October 8, 2009

CLIENT: U.S. Nuclear Regulatory Commission (NCR)
Office of Nuclear Reactor Regulation
Mail Stop 013-E19
Washington, D.C. 20555

TASK #2 SCOPE:

To determine the accuracy of and uncertainties involved in using the 3% head loss value of NPSH Required (NPSHR) for the reactor ECCS core spray and residual heat removal pumps (using the pumps in the Sultzer / Browns Ferry Report as examples of the types of pumps to be considered). Further, recommend how this information can be included in criterion for the NPSR margin.

Figure 1: NPSH test with suction head held constant (RHR)

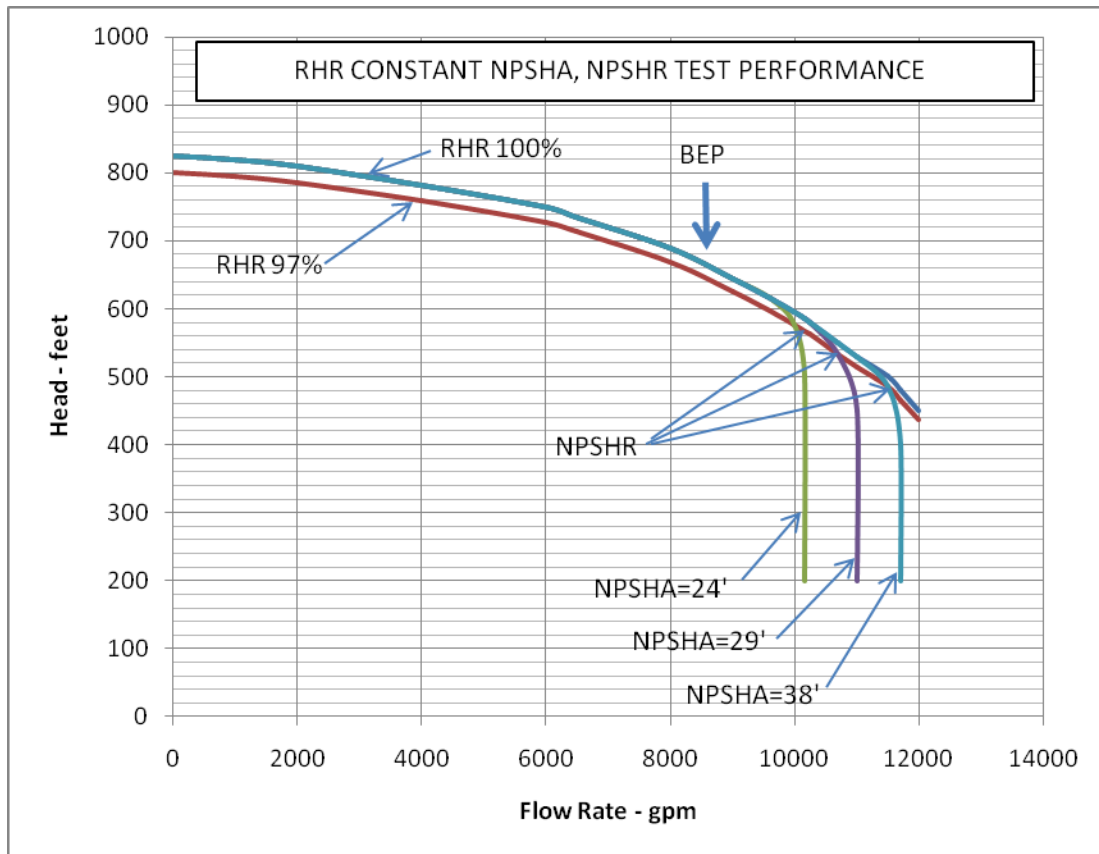
- a. An actual NPSH factory tests of the specific pump in question, tested in accordance with the Hydraulic Institute Standard (ANSI/HI 1.6): Figures 1 and 2 show one (of two) type of HI test (constant NPSHA) for the RHR and CS NPSHR performance. This is the most accurate (gold standard) method of determining the NPSHR (3%) of a pump. For best accuracy, the test should be conducted at the rated speed, and impeller diameter, with the NPSHA controlled by a vacuum pump. The individual measurement, allowable HI test fluctuations and instrument accuracy are shown in Table 1. The resulting net NPSHR accuracy of this method would be expected to be in the +/- 1 to 2 feet range (or +/- 2.5% to +/- 5%, whichever is larger), depending on the accuracy of the instrumentation and air content of the test liquid. If possible this method should be the preferred method.

- e. Finally, an NPSH field test could be performed (as shown in figures 1 & 2), if calibrated instruments (with proper straight runs of piping before and after the instruments) can be provided, the suction pressure can be throttled, and the flow rate can be varied and accurately measured. In some respects this could be the most accurate test, since any field speed changes or suction piping influence would be included in the test. The accuracy of this method is strongly dependent on how close the test can be to the Hydraulic Institute test criteria. A fair estimate of accuracy of this method would probably then be in the ± 1 to ± 10 feet range (or 2.5 to $\pm 30\%$ range), whichever is greater.

Figure 3: Deviation in NPSHR (3%) values for three similar RHR pumps

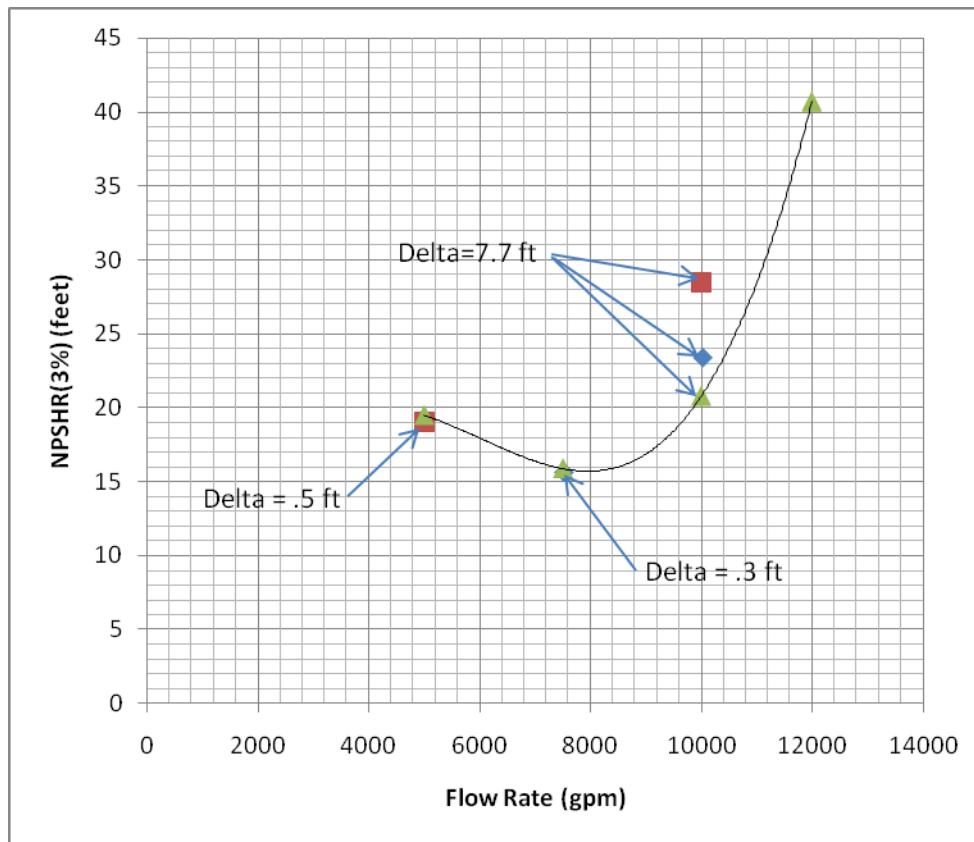
- b. The second most accurate method for determining the NPSHR of a pump would be to conduct a Hydraulic Institute NPSH test of a similar model and size pump, at the same speed and impeller diameter. The accuracy of this method for the three different RHR Sultzer pumps was in the range of +/- .1 to +/- 4 feet, as shown in figure 3. Generally the accuracy of this method would be expected to be in the range of +/- 2 to +/- 4 feet, (or +/- 5% to +/-15%, whichever is greater). The accuracy of this method depends on the accuracy of the test method and:
